Letter of Transmittal

PROVISIONS FOR ENCROACHMENT

- REQUEST FOR ENCROACHMENT (AWNING)

REQUEST ENCROACHMENT
INTO W SEVEN MILE RD.
AND HARLOW AVE.
AT 6874 W SEVEN MILE RD.

- REQUEST ENCROACHMENT

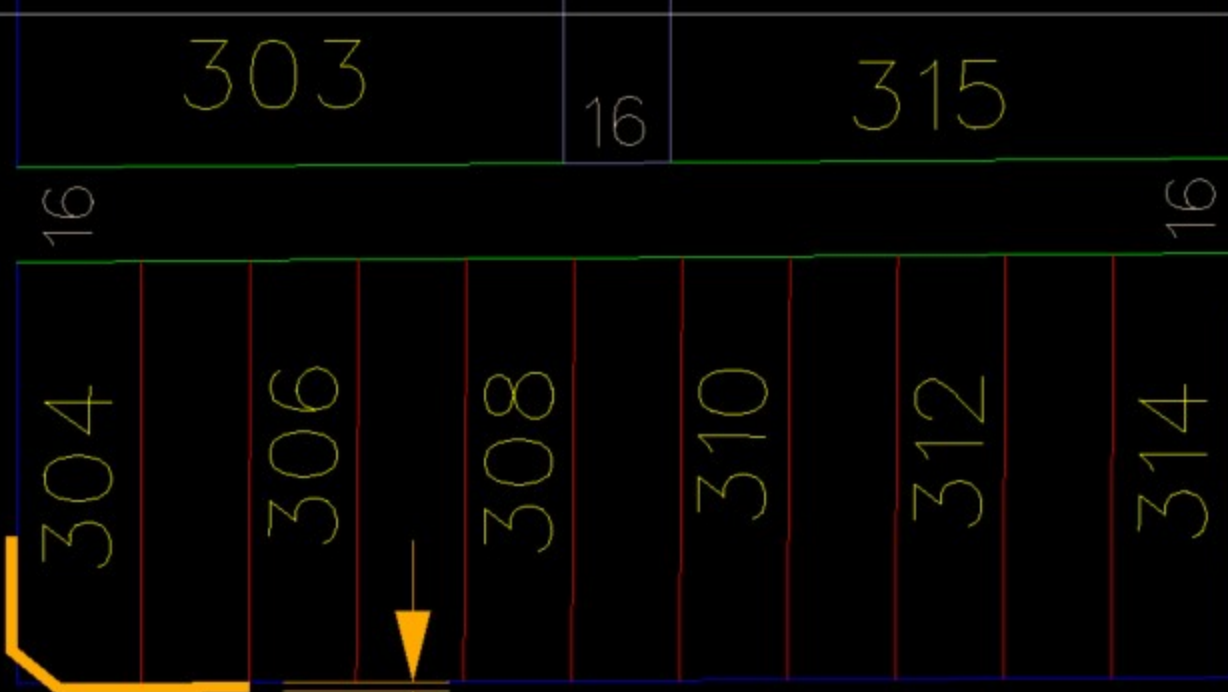
WHAT IS THE DEPTH OF THE AWNING?
